Modification of Development Consent

Modification 2

SSD-10448-MOD-2

788-882 Mamre Road, Kemps Creek NSW 2178

Landscape Concept Masterplan Stage 1

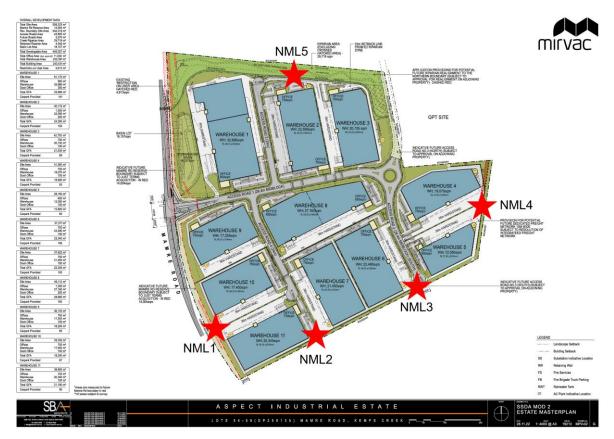
20. Delete Figure 4 and replace with the following:
